## JOINT REGIONAL PLANNING PANEL (Sydney East Region)

JRPP No	2015SYE030
DA Number	14(68)
Local Government Area	City of Botany Bay
Proposed Development	Joint Regional Planning Panel and Integrated development application for the construction of a mixed use development comprising 3 x 8 storey buildings containing 351 residential apartments and 2 commercial tenancies, and basement car park for 605 spaces. A Draft Voluntary Planning Agreement proposed to the application under S93F of the Environmental Planning and Assessment Act, 1979 accompanies the development application.
Street Address	16 Pemberton Street and 1619 Botany Road Botany. Lots 1 & 2 DP 913863; Lots C & D DP 414612; Lot 1 DP 135377; Lot 1 DP 656310; Lots B & C DP 402187; and Lots B & C DP 380476.
Applicant/Owner	Applicant – Krikis Tayler Architects Owner – JKN Australia Pty Ltd
Number of Submissions	21.01.2015 – 23.02.2015 (notification of scheme with 343 units & 562 car spaces) – 48 objection letters and 2 x petitions totalling 83 signatures

Recommendation	<p>The Sydney East Joint Regional Planning Panel (JRPP), as the Determining Authority resolve to refuse development consent under Section 80(3) of the <i>Environme

*Figure 13: Plan extract showing areas where view sharing and outlook is significantly affected compared to the masterplan layout (Source: Urban design review prepared by Urbanac).*

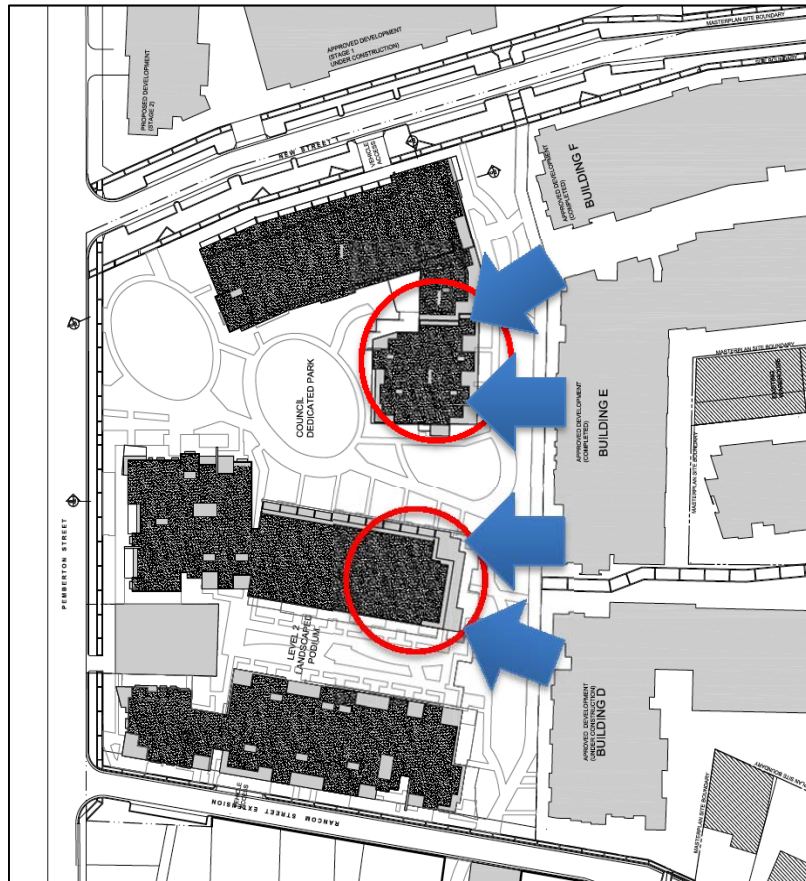
The consolidation and reorientation of Buildings B1 and B2 closer to the existing development to the immediate east and in front of that site’s east-west pedestrian link obstructs outlook from Building D and E to the west.

The Urban design review goes onto state that the placement of buildings along the north-south pedestrian link adversely impacts on opportunities for view sharing towards the west, and a generally less expansive outlook across the site. This is demonstrated in the Figure below.

Council considers that the proposed development results in an urban design that creates significant adverse amenity impacts on the future residents and adjoining residents. Council considers that the masterplan represents a superior urban design response in terms of building placement and the resulting amenity impacts.

Figure 14: Plan extract showing the lack of alignment of buildings and the blocking of potential views and the flow of open space through the precinct (Source: Urban design review, prepared by Urbanac)

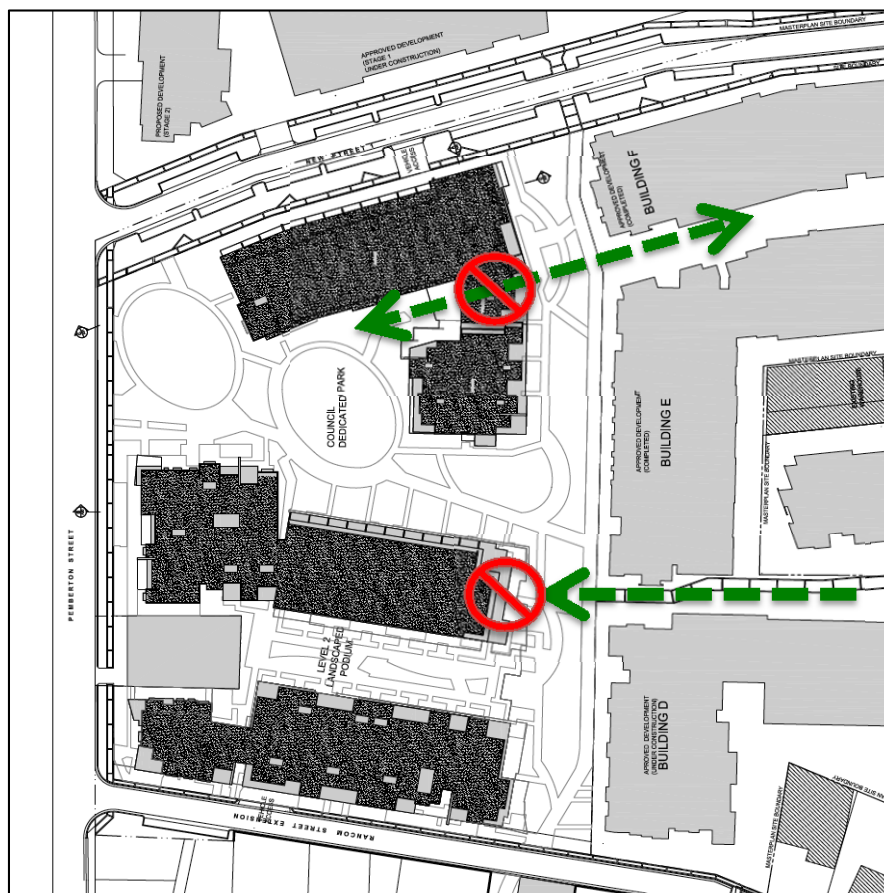
The urban design review indicated the built form of the Parkgrove East development establishes the context to the east of the site, with an arrangement of buildings and spaces separating buildings to which the proposed development should respond. There is, however, little or no continuity between the layout of building forms for the proposed development and those buildings already constructed on Parkgrove East. The proposed buildings are generally not aligned with existing buildings, and the spaces separating the buildings do not flow into Parkgrove West to form extended vistas or potential view corridors. Instead, these are instead blocked by proposed buildings. This is illustrated below.

The Urban design review considers that the appropriate urban design response is to have regard to the layout of the buildings on the adjoining blocks and in particular the alignment of open spaces separating those buildings. Better urban design practice would seek to align those open spaces in the new development so that there is a continuity and flow of space across the precinct and an opening up of views through the precinct.

In light of the above, it is Council's view that that the proposed building layout is not considered to be a satisfactory response to the context established by Parkgrove East.

Figure 15: Shadow Diagrams 9am. Proposal (left), masterplan (right)

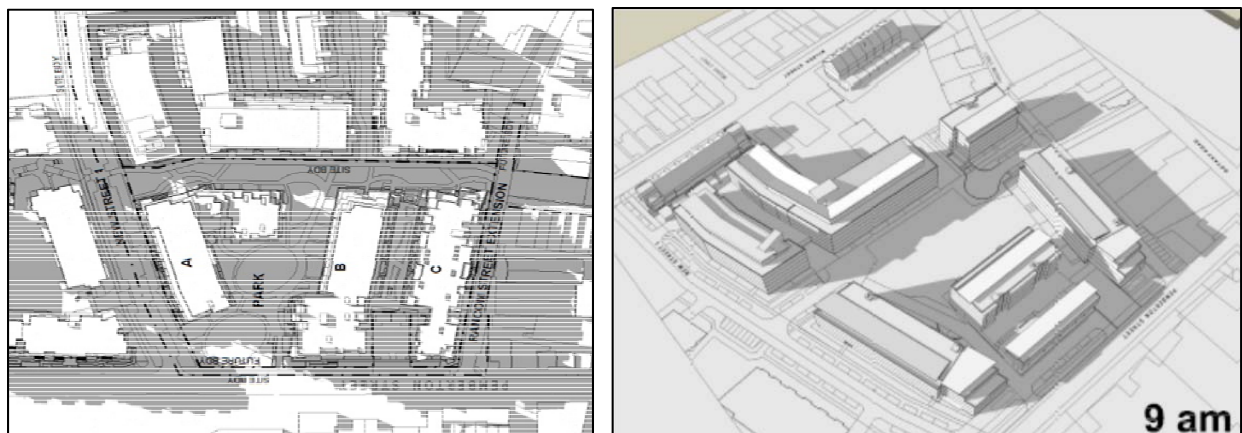
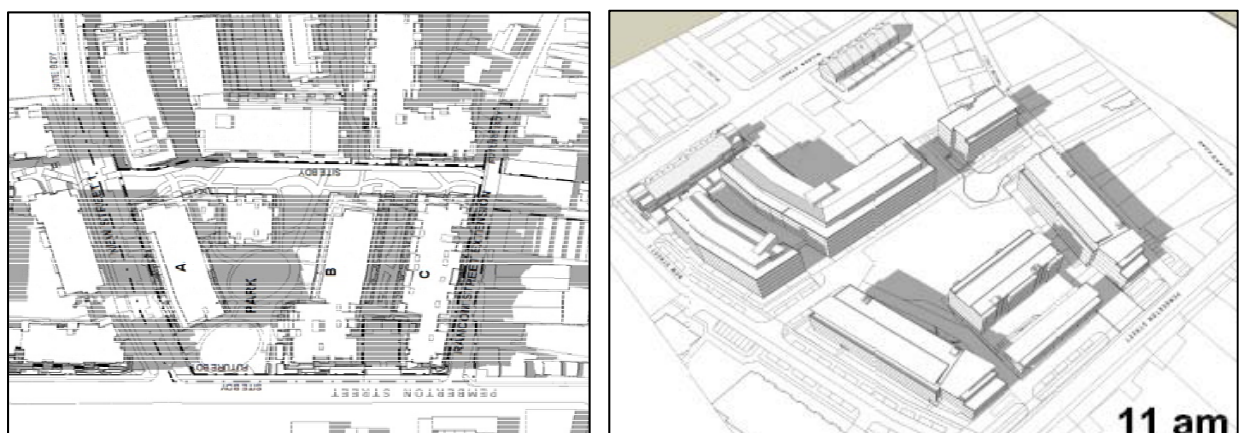
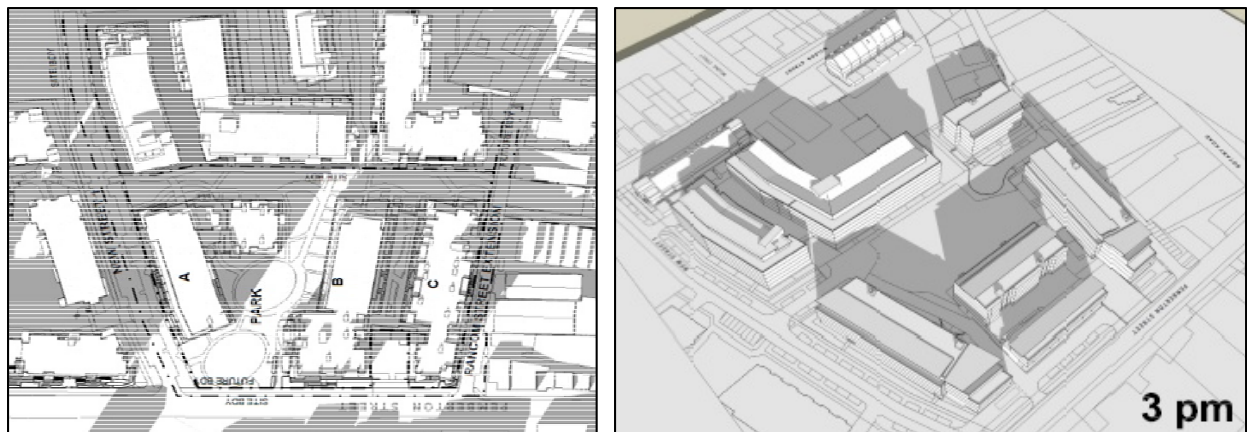
Whilst it has been discussed in the 'Masterplan' section of this Report, it warrants reiteration that if the design had arranged buildings in a north-south orientation (and complied with the LEP height control), such as that shown in the masterplan, overshadowing impacts would be substantially lesser.

The Urban design review concludes that overshadowing with the masterplan design is less as the spaces between the long buildings would be able to receive full sunlight in the middle of the day throughout the year. The public open space shown in the master plan as a single area with a greater north-south dimension would also be subject to less overshadowing overall from a building to the north along New Street.
